Access Compliance Report Public Rights-of-Way (Curb Ramps)

Main Street: SILVER_FOX_RD Cross Street: DRUID_LN Location: SW

ADA ID: RPRK211206165841 Ramp Type: Type 1 - Perpendicular Diagonal Initial Pass/Fail: Pass Overall Compliance: No Severity Score: 10

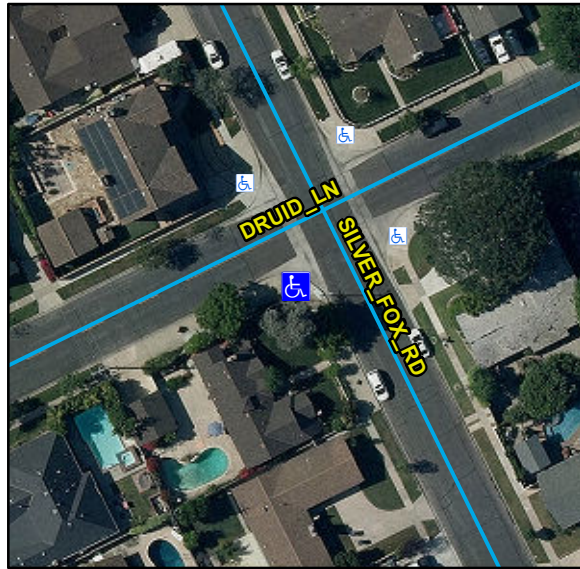
R304.2.2, R204.3, R305, STD 1115

Remove & Replace Curb Ramp With Two New Directional Ramps or Equivalent.
